ADDENDUM 01

This addendum is considered to form part of the contract document issued for this Request for Quotation. Its content precedes previously issued documents in case of conflicting information.

E-000

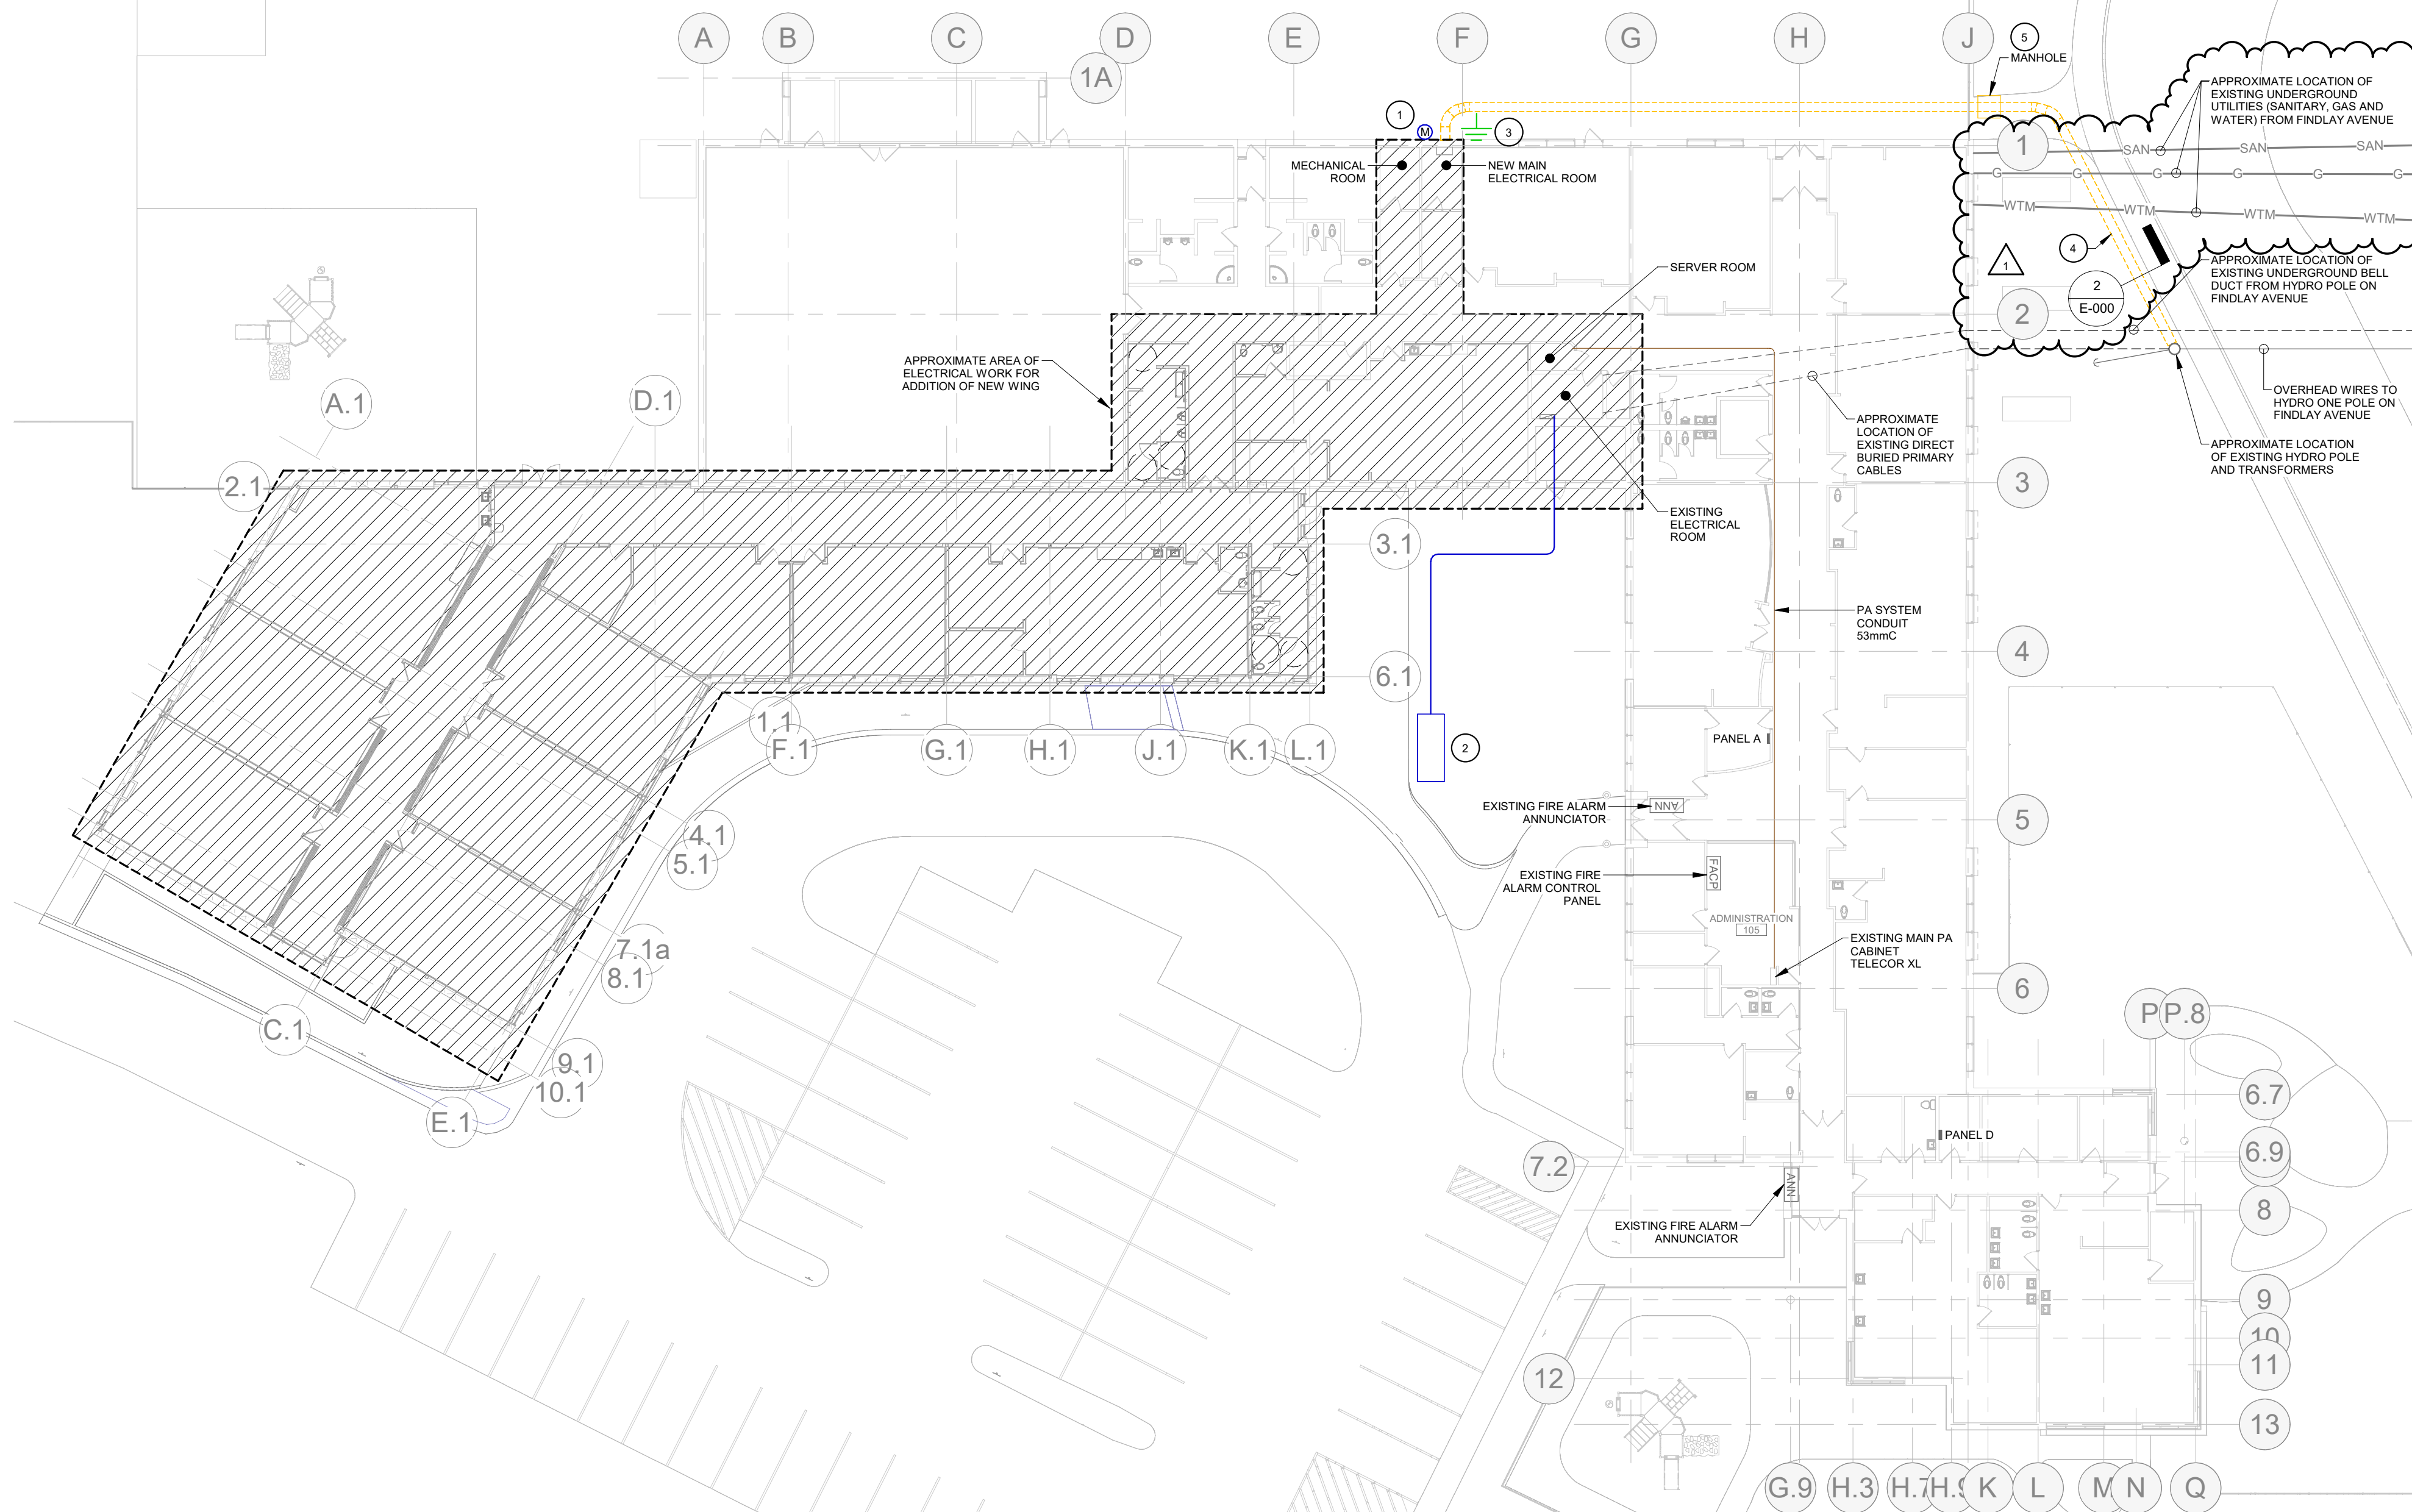
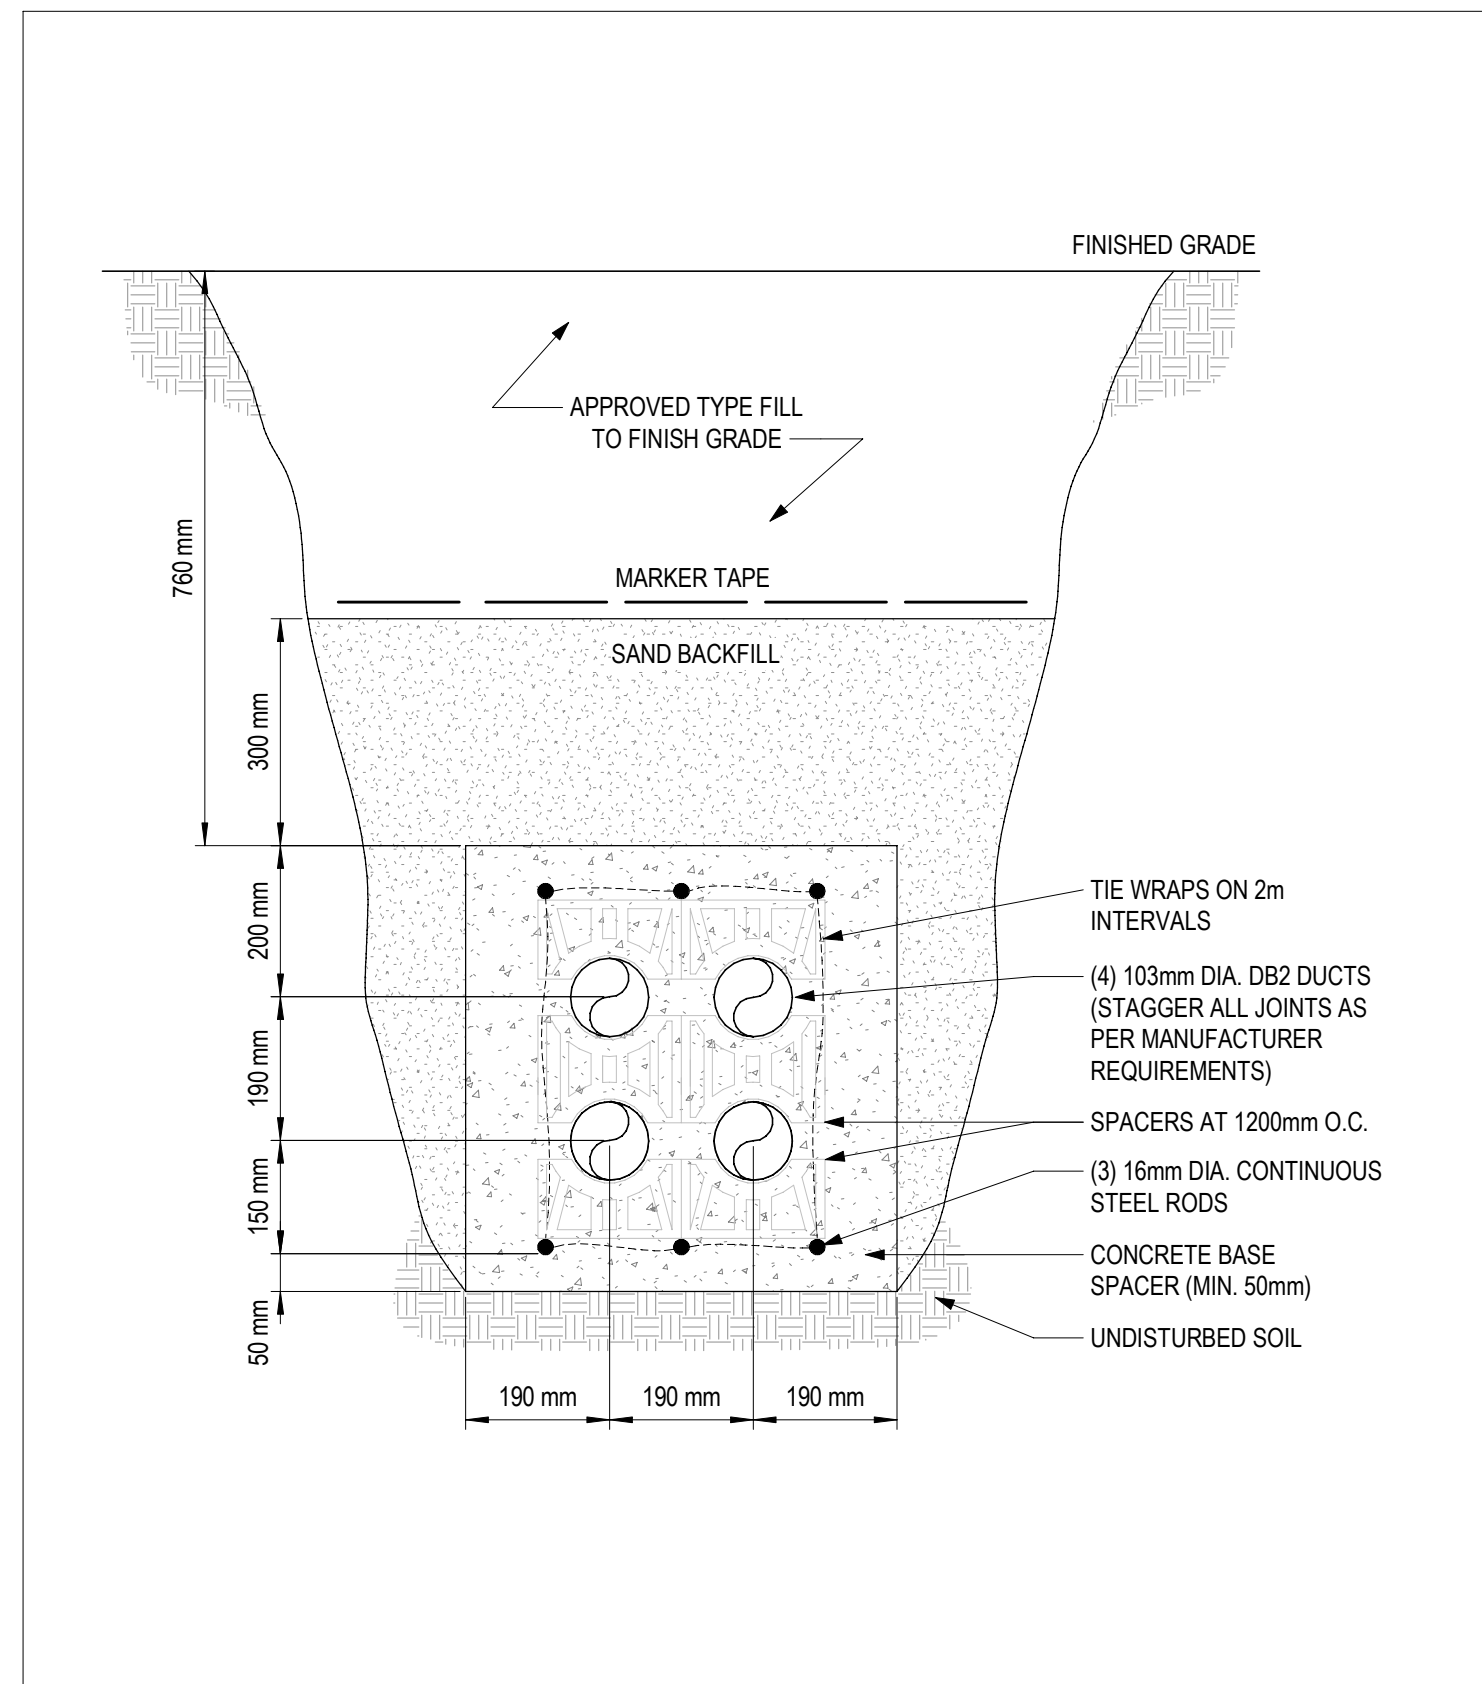
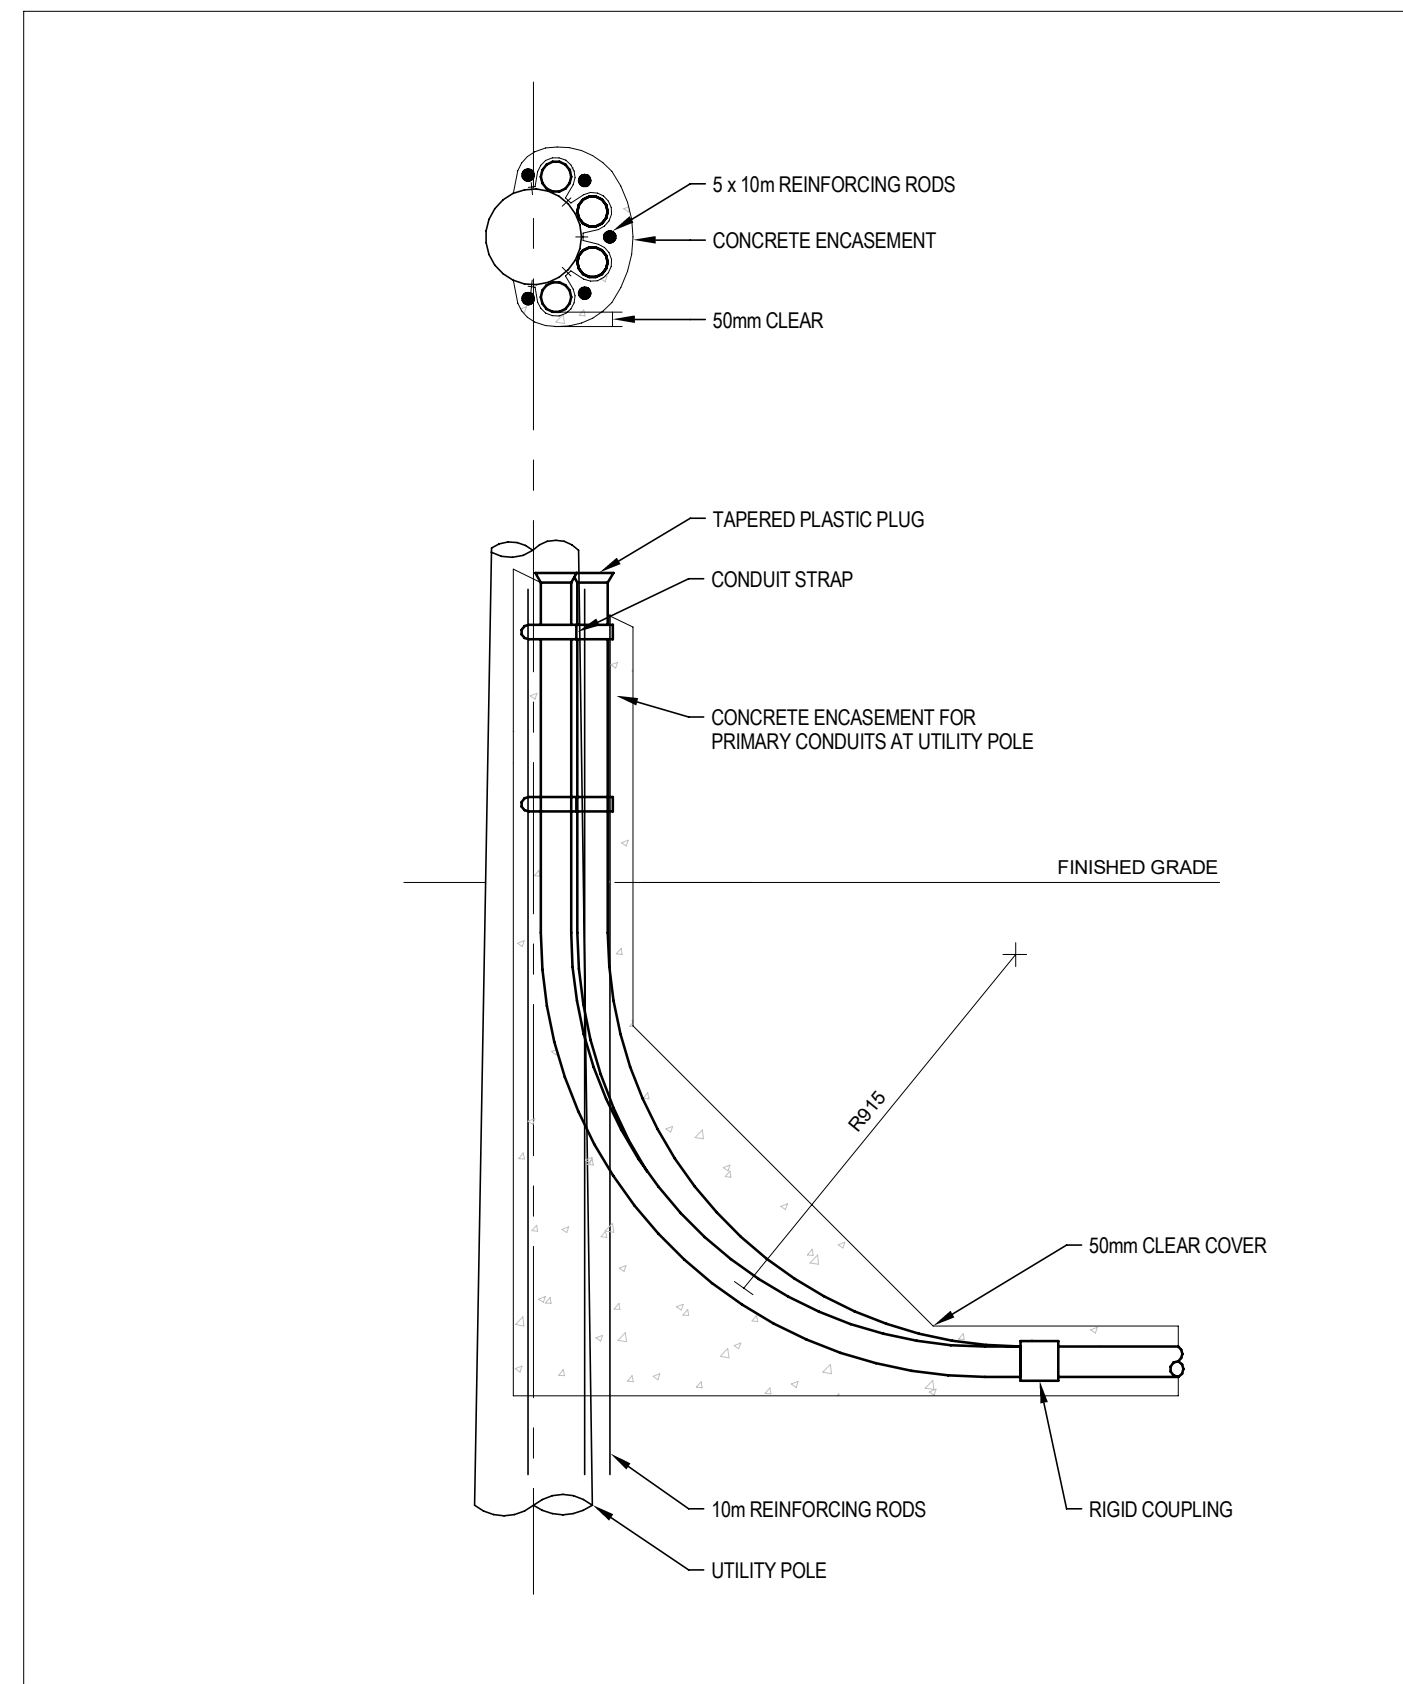
2.1 Drawing E-000
